FILE P.I. # 0005320 **OFFICE** Design Policy & Support
NHS00-0005-00(320)
Dooly County
GDOT District 3 - Thomaston **DATE** January 24, 2013
I-75@SR 215 Interchange Improvements

SUBJECT APPROVED REVISED CONCEPT REPORT

Project NHS00-0005-00(320) (I-75 @ SR 215 Interchange):

**DEPARTMENT OF TRANSPORTATION
STATE OF GEORGIA
REVISED PROJECT CONCEPT REPORT**

DOOLY COUNTY

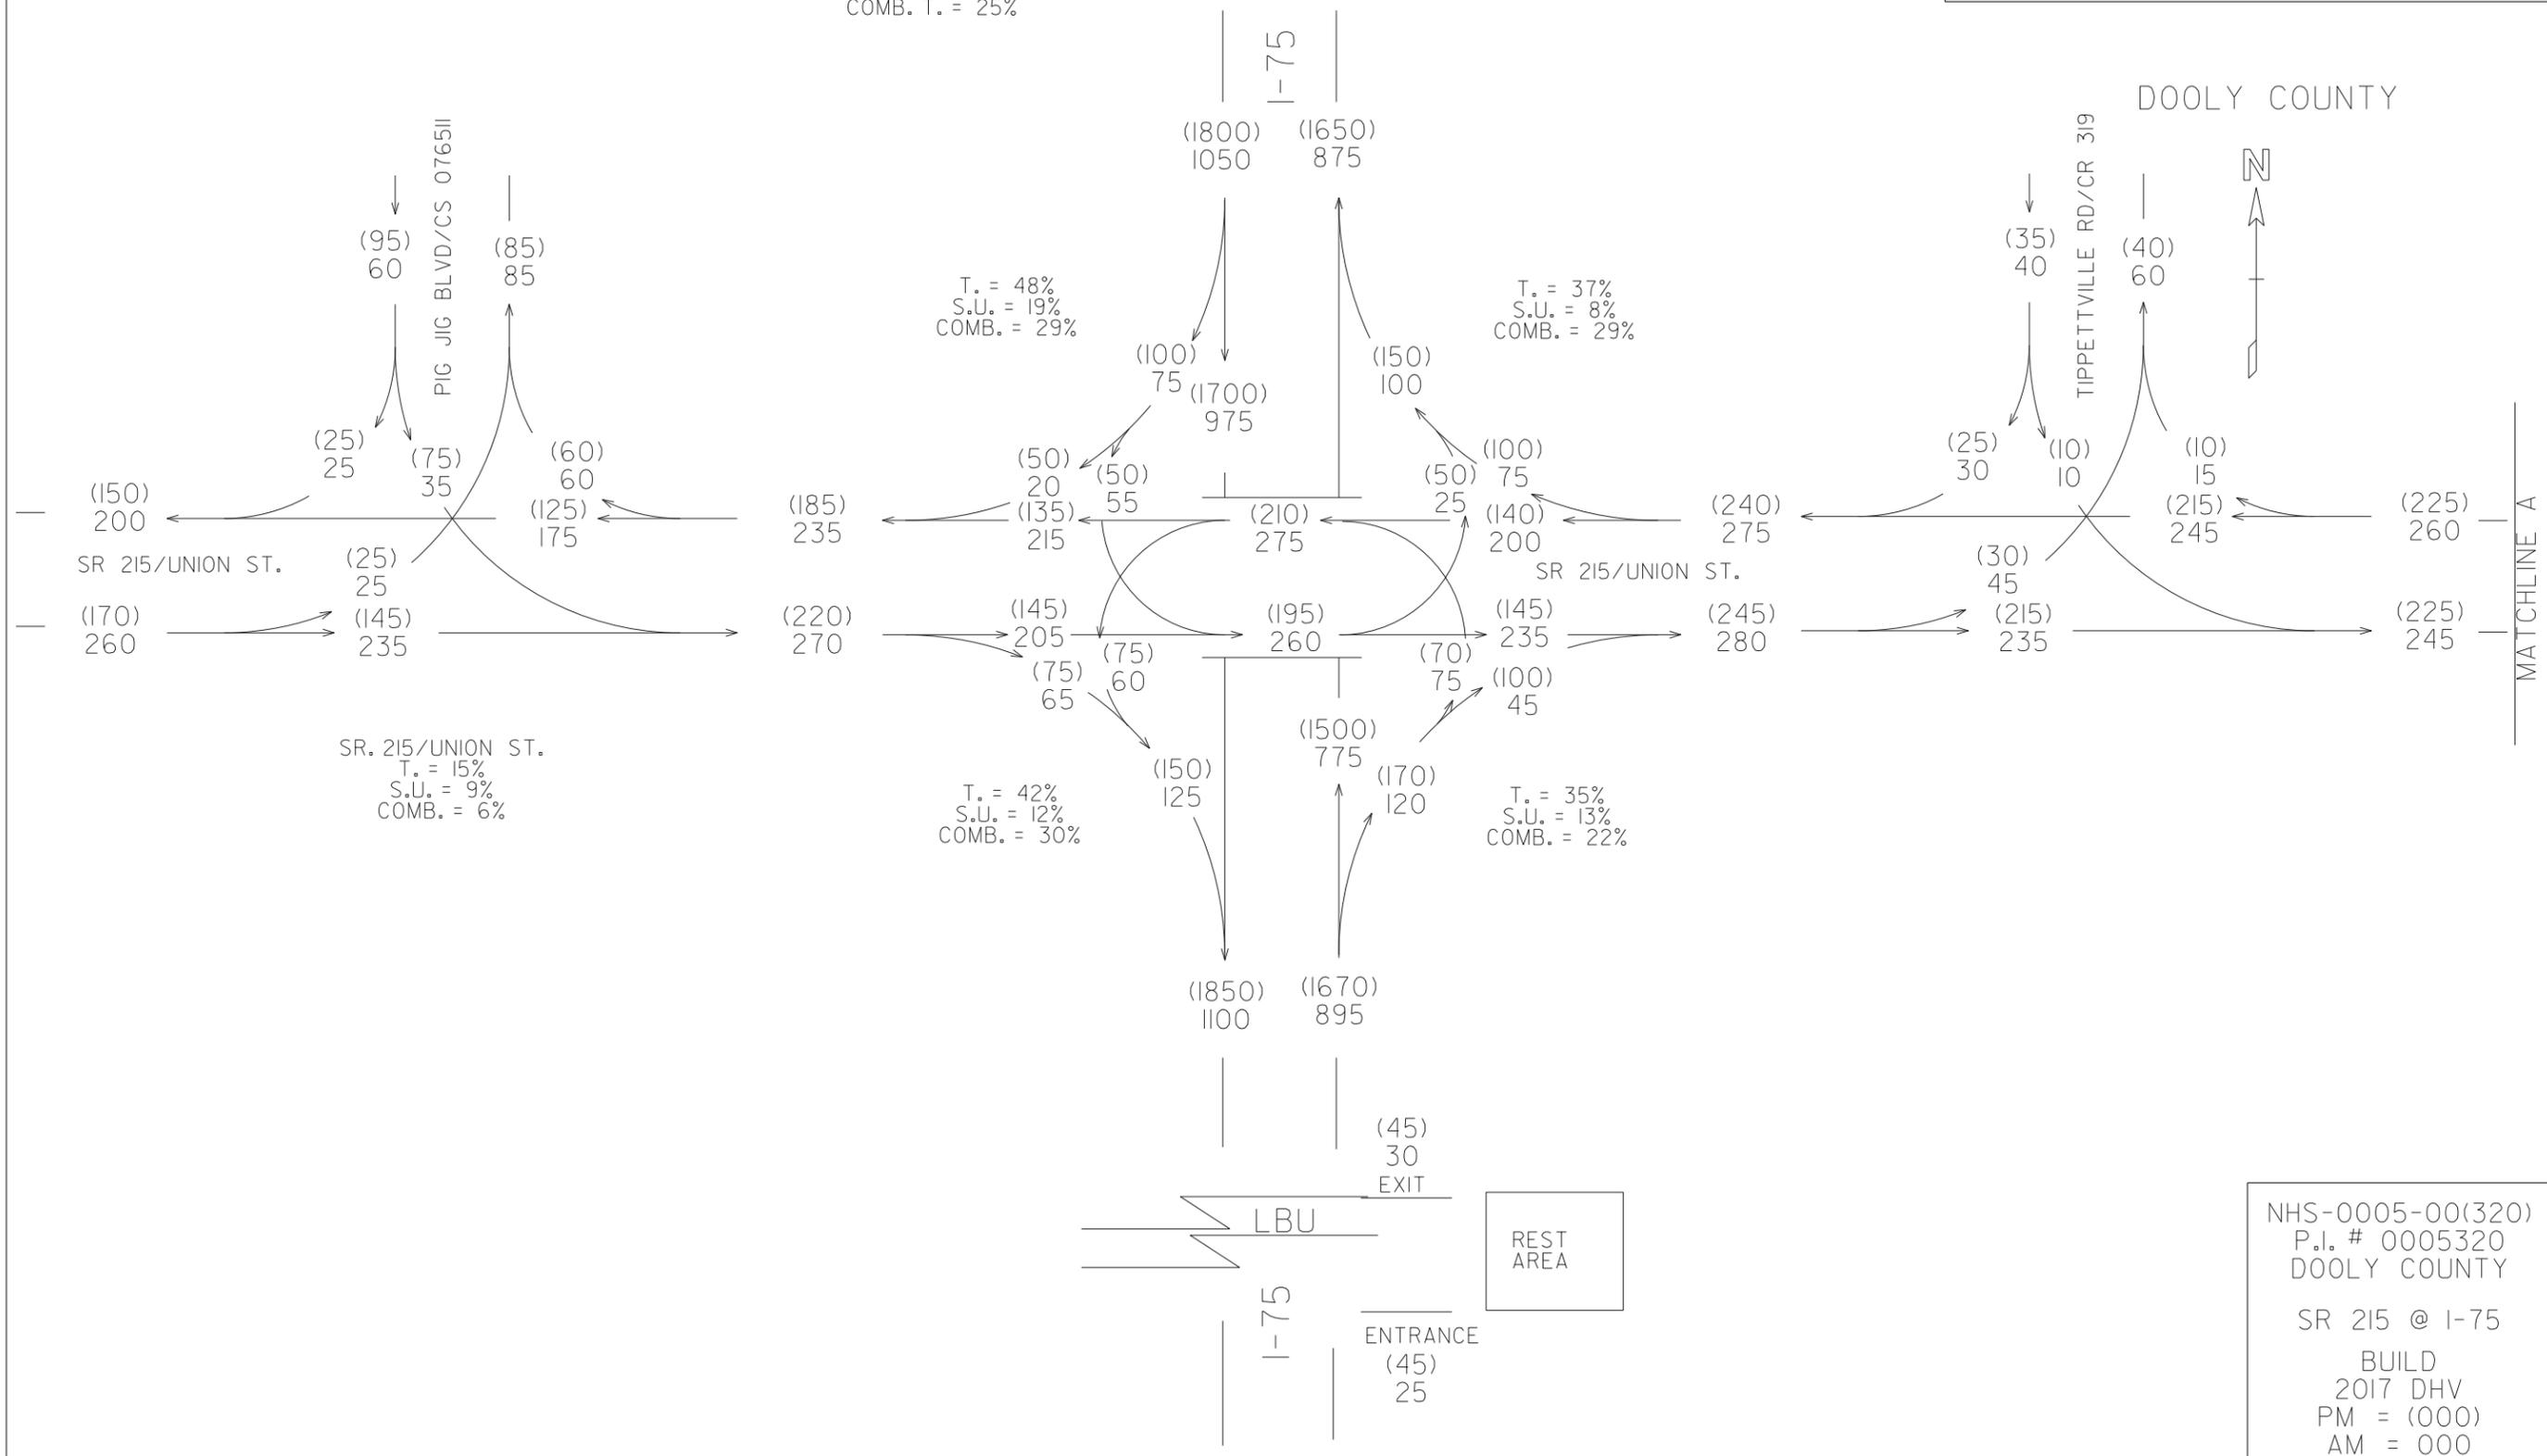
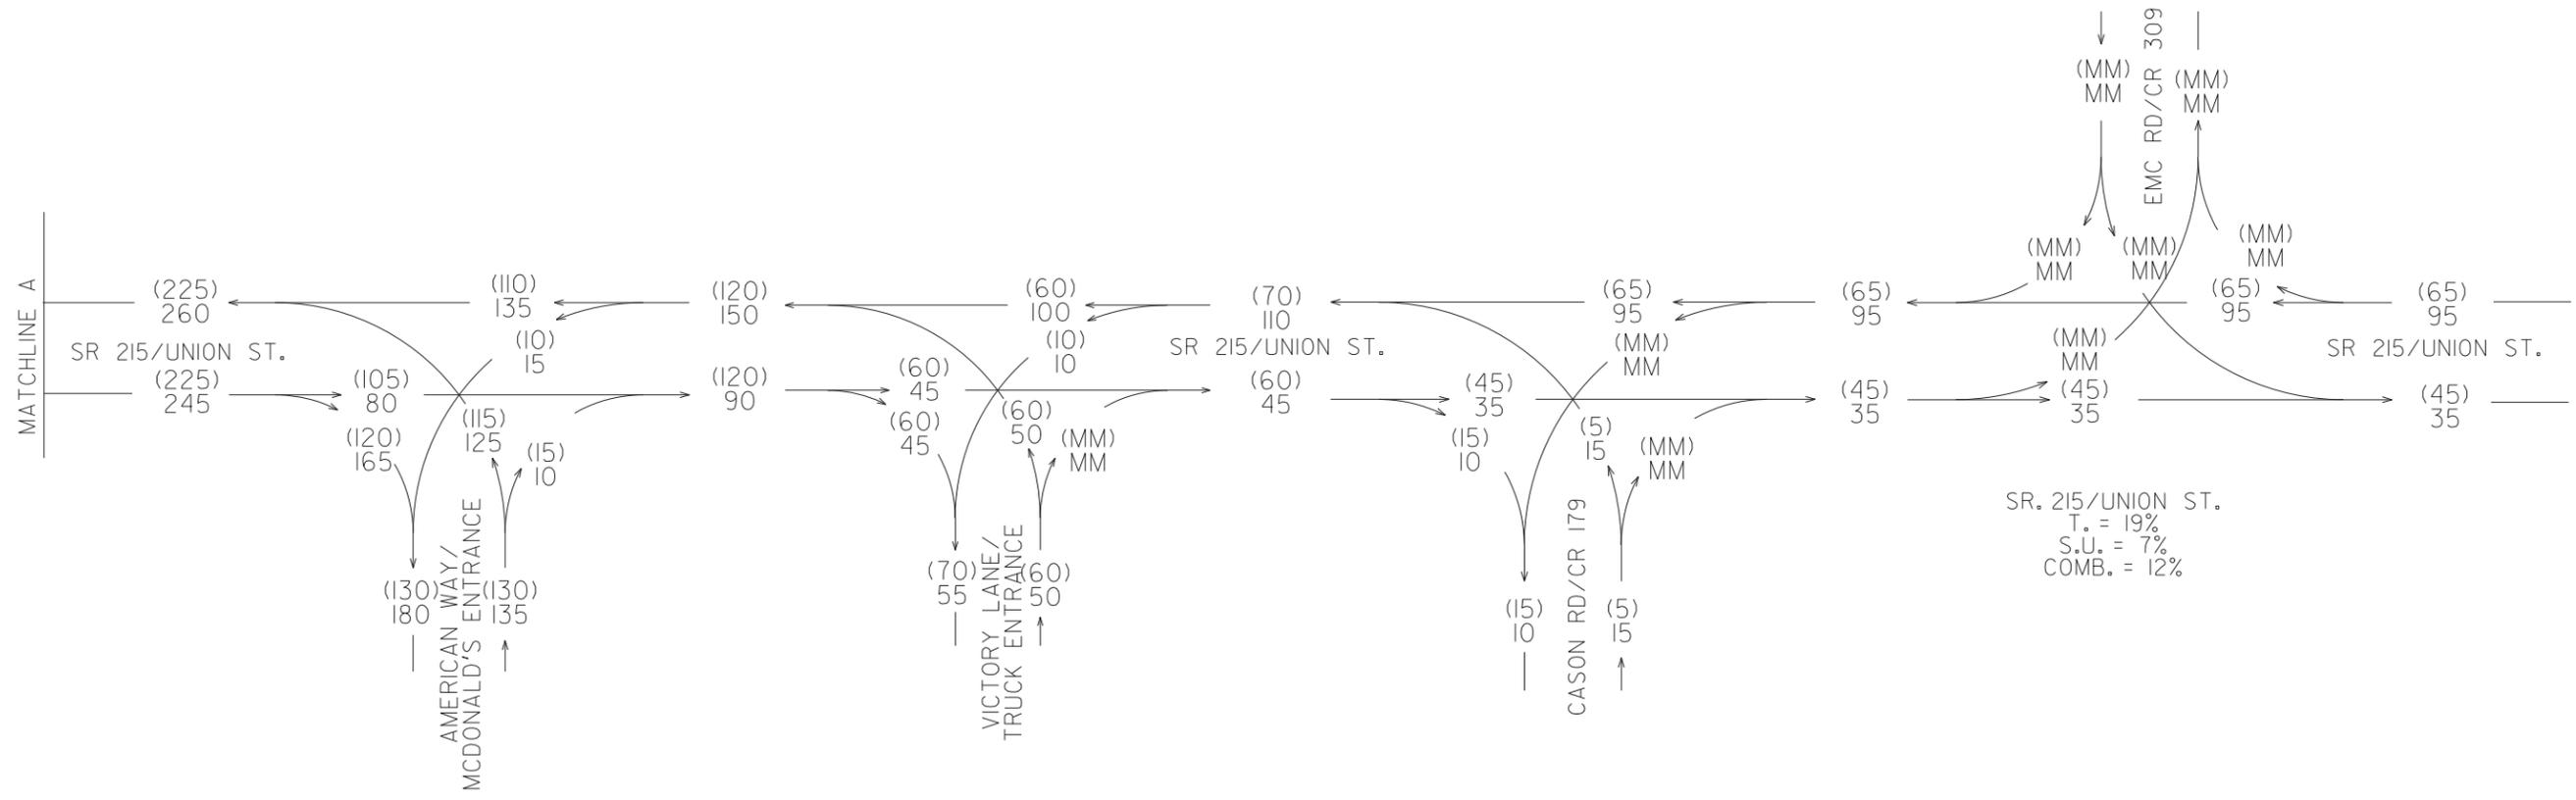
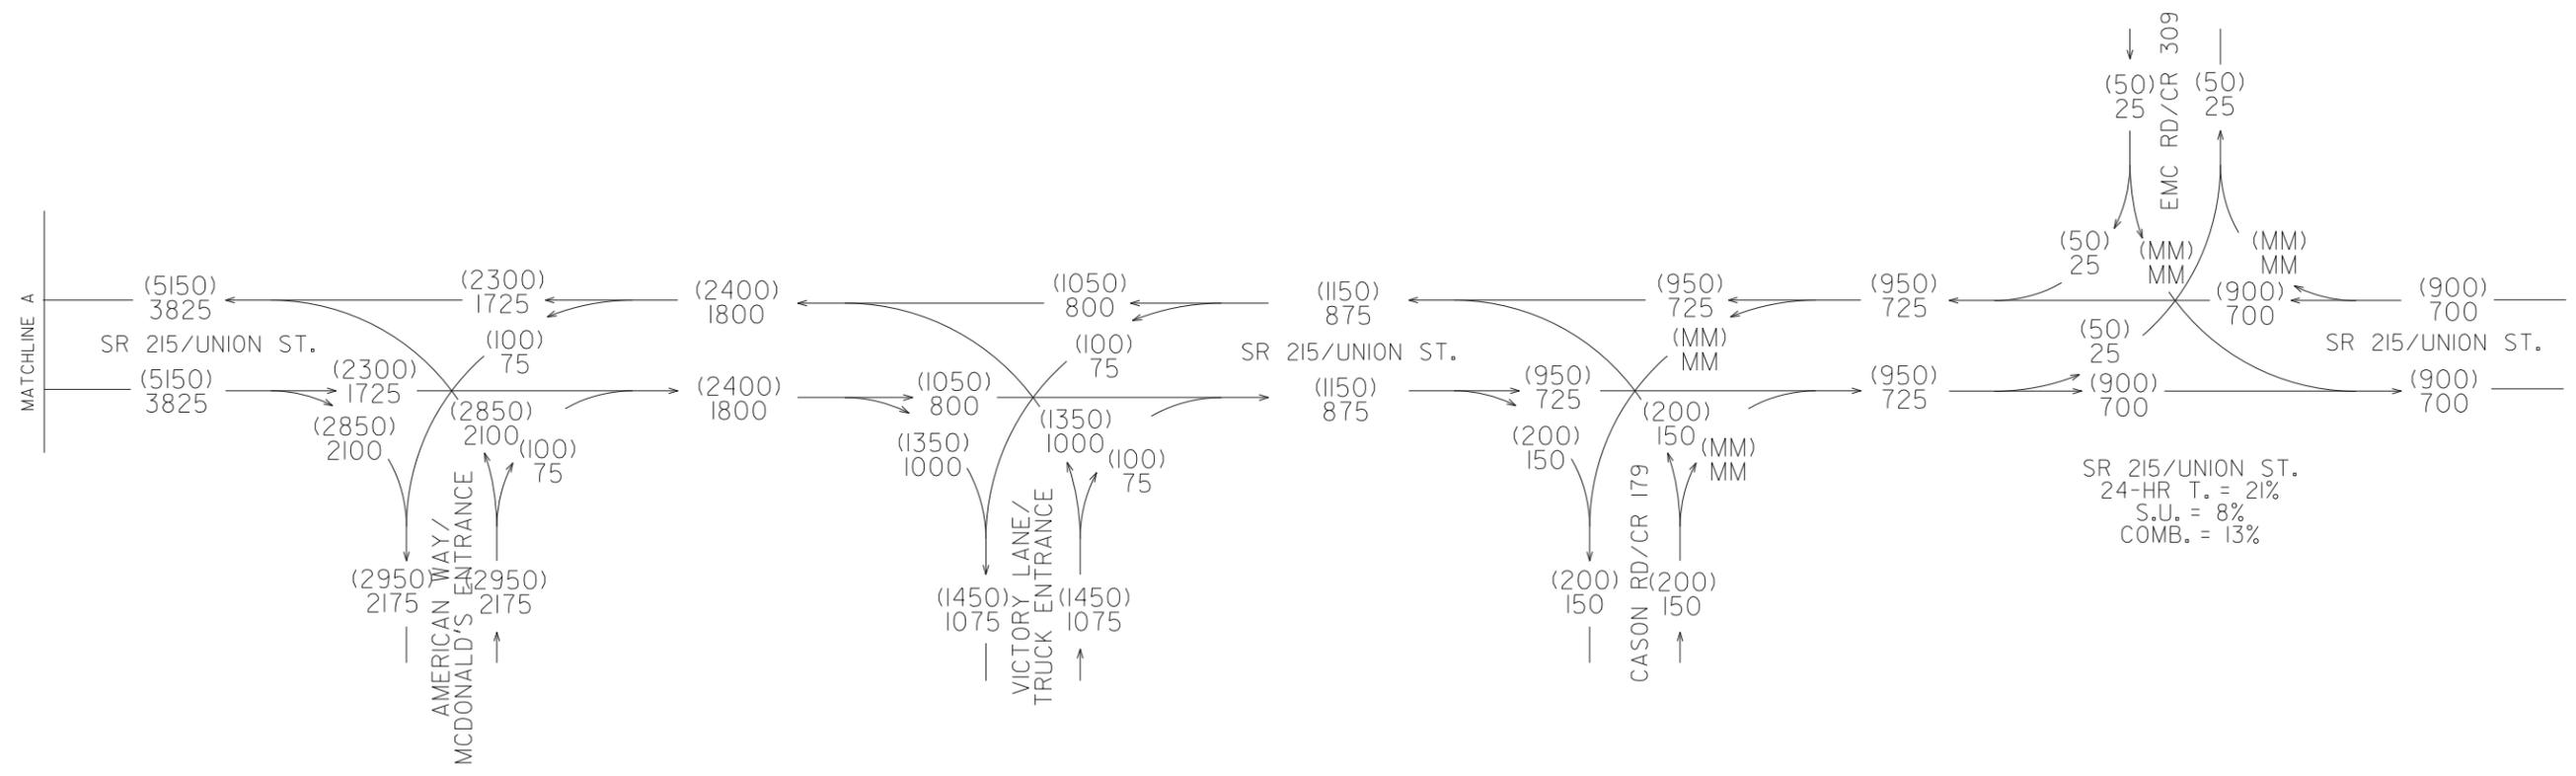
- The Traffic Diagrams provided for the proposed project Build Condition do not reflect the description of the Build Condition of the proposed project. Please review the project information and ensure that all related project information is consistent with the proposed project, as analyzed by GDOT.
- Please ensure that all data presented within the report is accurate and consistent.
